**SUBDIVISION COMMITTEE
METROPOLITAN AREA PLANNING COMMISSION**

**STAFF REPORT
(Final Plat)**

CASE NUMBER: S/D 95-22 DEINES ADDITION

VICINITY MAP:

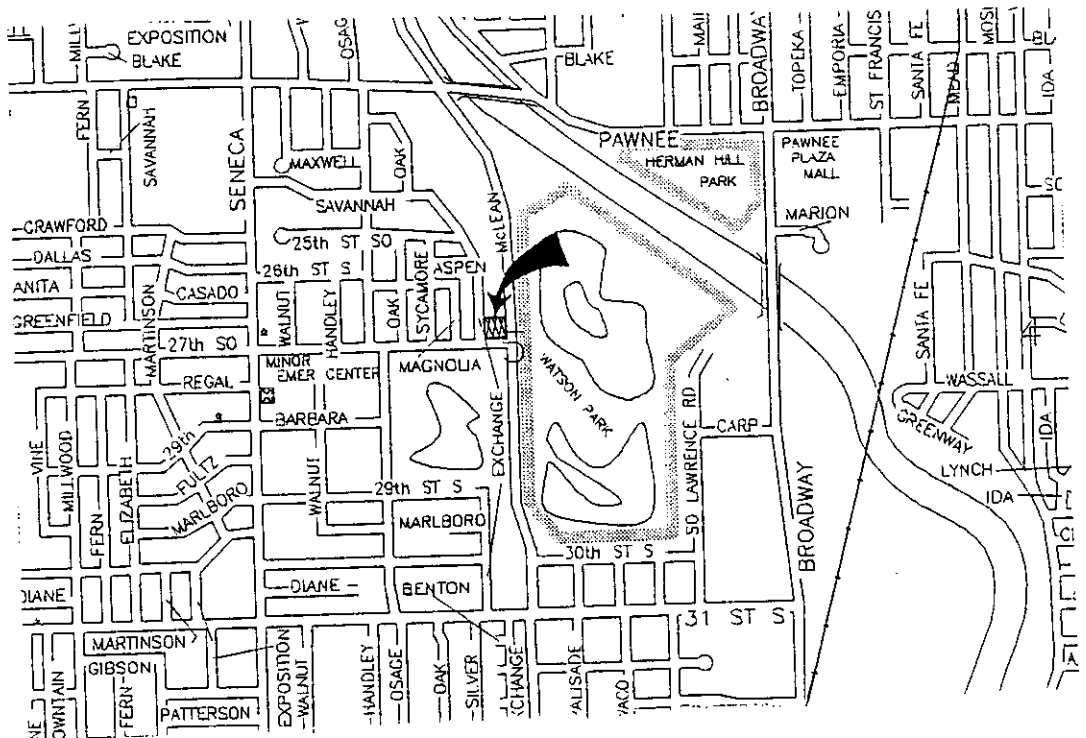
NOTE: While this plat involves a developed area of the City, the site has never been platted. Existing structures, including two (2) houses are indicated on the sketch plat. As now being platted, these homes will be divided by a common lot line between Lots 2 & 3. While under "AA" One-family zoning, it is common for a home to be built across a lot line, that is, a building site can involve a lot plus portions of an abutting lot, two homes cannot be allowed on the same "building site" [lot(s)].

- A. Prior to this plat being released for recording, one of the two existing houses located along the common lot line of Lots 1 & 2 shall be removed. A letter shall be submitted to Planning confirming this removal.

- B. Guarantees shall be provided for the relocation or abandonment of any public utilities not being covered by a utility easement. Specifically, a sanitary sewer line across Lot 2 will need to be abandoned due to the plat's vacation of the associated easement. Also, along the south line of Lot 3, what appears to be the extension of a public water line is not being covered by an easement. City Engineering and the Water Department representative need to confirm any such requirements.

- E. The applicant is advised that other structures located on this site will also need to be removed if or when development is requested for any of these lots. That is, on Lot 1 the indicated structures will be in violation of required sideyard setbacks if or when an individual requests permits to build a home on that lot. Similarly, even when one of the homes is removed from Lots 2 & 3, no other home can be allowed on either lot as long as one of these existing structures remain.
